HISTORIC AND DESIGN REVIEW COMMISSION

April 06, 2022

HDRC CASE NO: 2022-117
ADDRESS: 527 HAYS ST
LEGAL DESCRIPTION: NCB 529 BLK 2 LOT E 51.12 FT OF S 92.5 FT OF 14
ZONING: R-6, H
CITY COUNCIL DIST.: 2
DISTRICT: Dignowity Hill Historic District
APPLICANT: Megan Suermann/SUERMAN PATRICK & SUERMANN MEGAN
OWNER: Megan Suermann/SUERMAN PATRICK & SUERMANN MEGAN
TYPE OF WORK: Window replacement, shutter installation, exterior alterations, painting
APPLICATION RECEIVED: March 04, 2022
60-DAY REVIEW: Not applicable due to City Council Emergency Orders
CASE MANAGER: Claudia Espinosa

Example of window to be replaced (same size in white vinyl), will convert extra room back into a garage

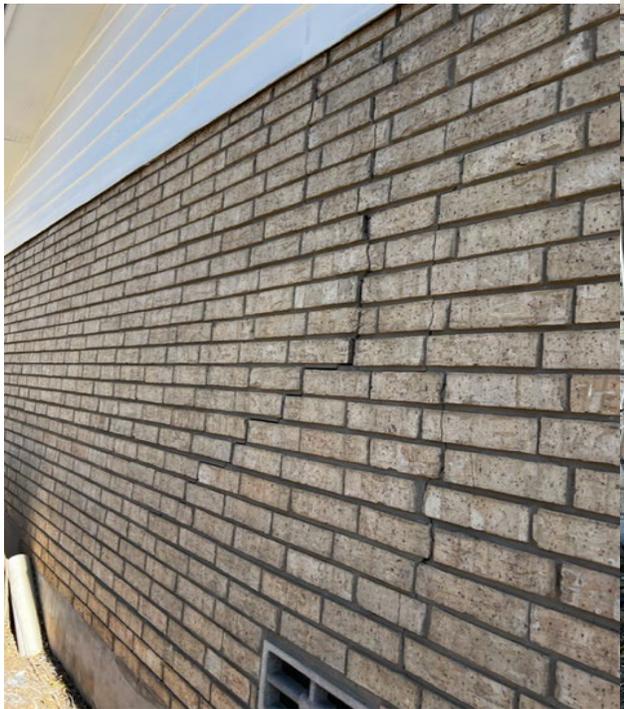
- c. WINDOW REPLACEMENT – The applicant has proposed to replace the existing, aluminum windows with new vinyl windows. The windows that have been proposed by the applicant are white, vinyl windows that feature a nailing fin. Staff finds the proposed replacement windows to be inconsistent with the Guidelines and staff's standards for replacement windows. The replacement of the existing, aluminum windows may be appropriate provided the replacement product meets staff's standards, noted in the applicable citations.

1. Staff does not recommend approval of item #1, the painting/limewashing of brick, based on finding b. Staff recommends the brick remain unpainted.
2. Staff does not recommend approval of item #2, the replacement of the existing, aluminum windows with white vinyl windows, as noted in finding. Staff recommends that the applicant install windows that are consistent with staff's standards for replacement windows, as noted in the applicable citations.
3. Staff does not recommend approval of item #3, the installation of window shutters based on finding d.

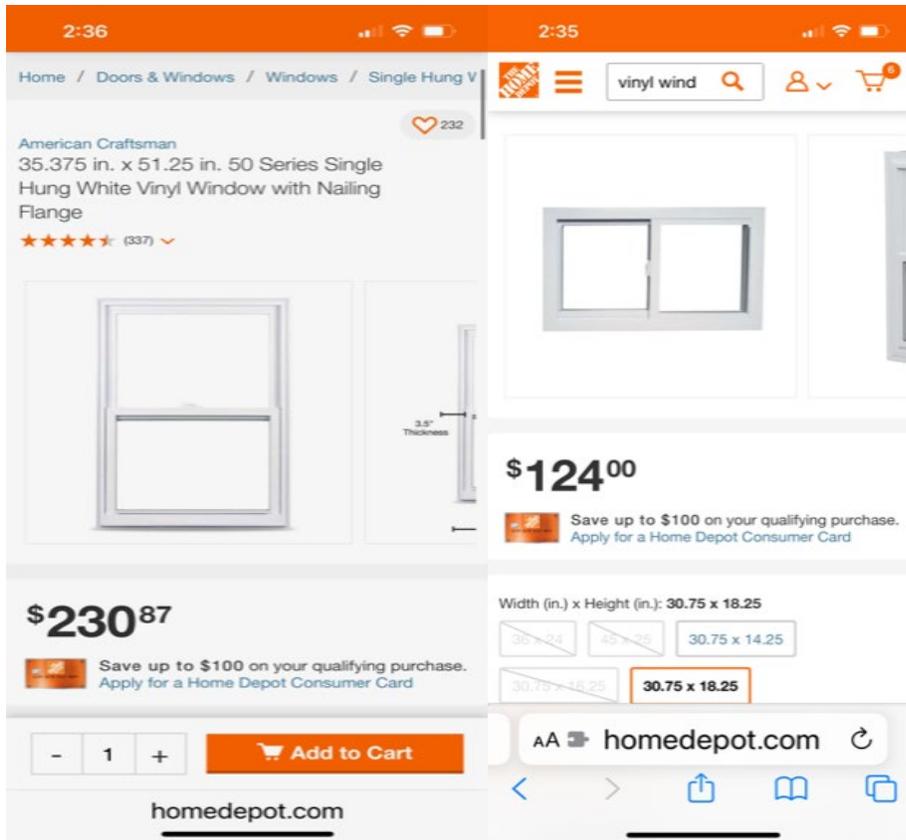
- b. BRICK PAINTING – The applicant has proposed to apply a white lime wash to cover the existing, tan brick. Per the Guidelines for Exterior Maintenance and Alterations 2.A.i., historically unpainted brick surfaces should remain unpainted. The proposed painting/application of limewash is inconsistent with the Guidelines.

Breathable material I'd like to use over brick after foundation repair to hide cracks to improve aesthetics.

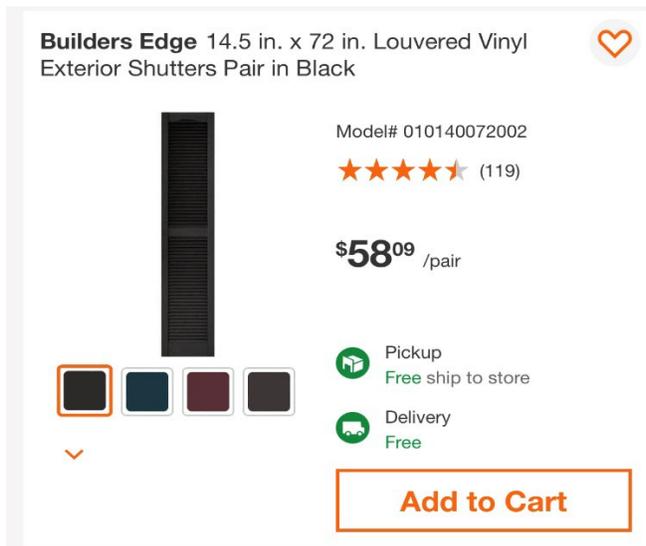
I'd like to replace aluminum windows with white vinyl windows to improve energy efficiency and to improve operability after foundation repair. They will be the same size, no framing required.

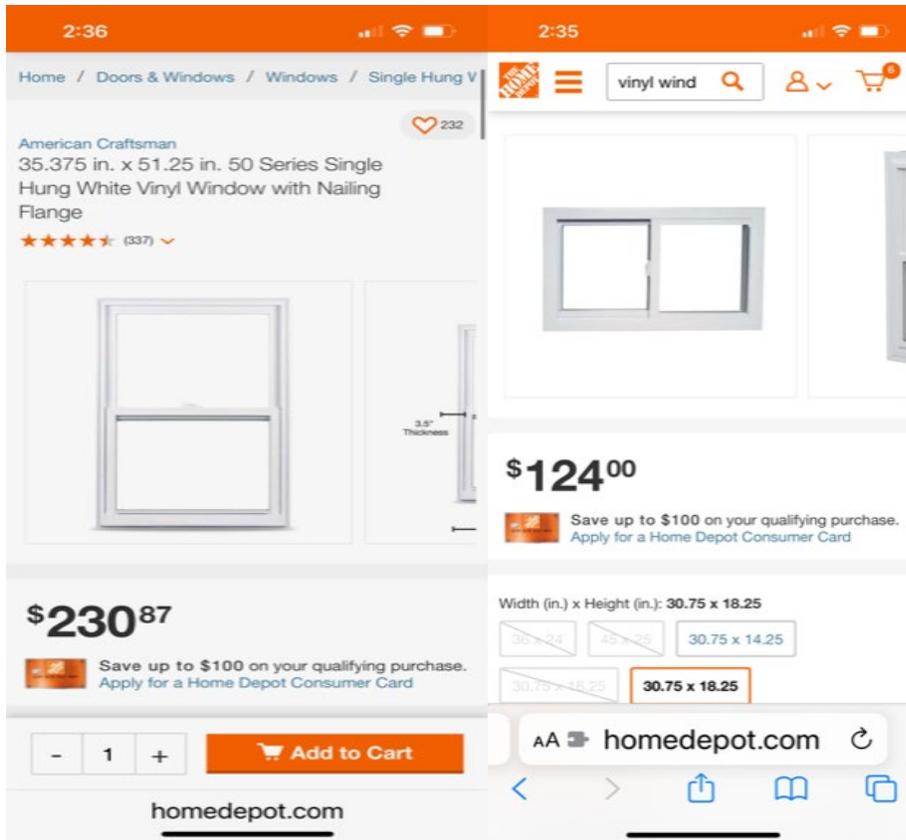
- d. SHUTTER INSTALLATION – The applicant has proposed to install black shutters at the front windows. The Guidelines for Exterior Maintenance and Alterations 6.B.x. notes that shutters should not be installed where they did not historically exist. Staff finds the proposed installation of shutters to be inconsistent with the Guidelines.

I'd like to add shutters to the front windows to improve aesthetics. Shutters were very popular mid-century modern exterior. They will be the same height and width as the front windows and appear operational.
